Front Soakaway
Detail SA01

Rear Soakaway
Detail SA02

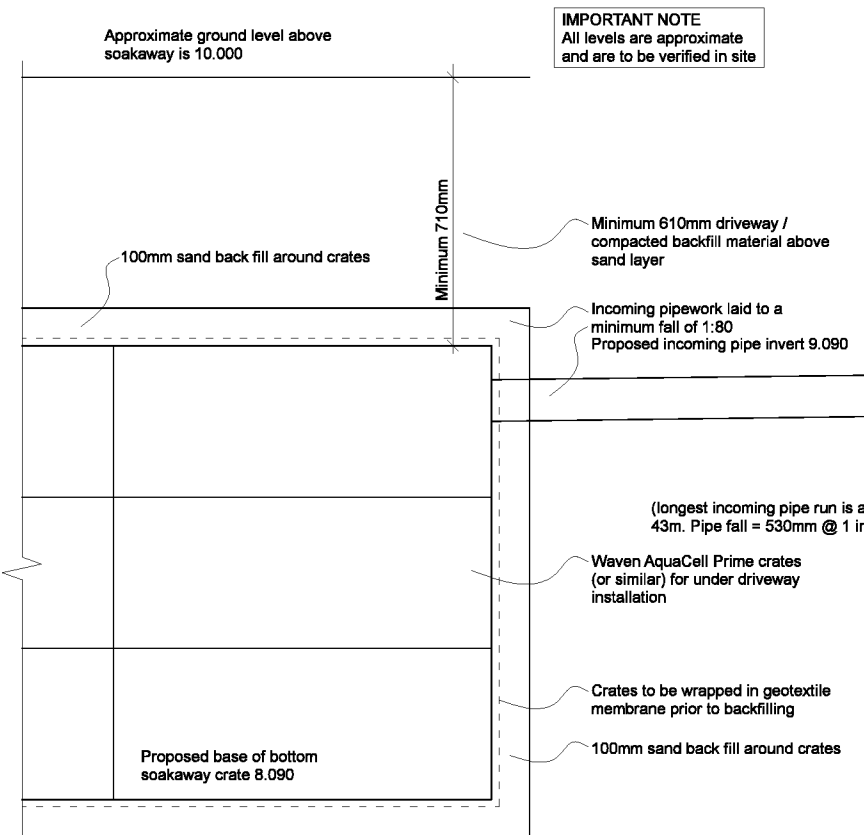
Revision A	4/11/2019	Soakaway size increased Easy bends replaced with manholes Pipe gradients and pipe diameters added Incoming soakaway pipe invert level on soakaway SA01 raised
Revision B	18/12/2019	Soakaway SA02 revised
Revision C	14/01/2020	Cover and Invert Levels added to surface water manholes
Revision D	29/01/2020	Pipe bedding details added
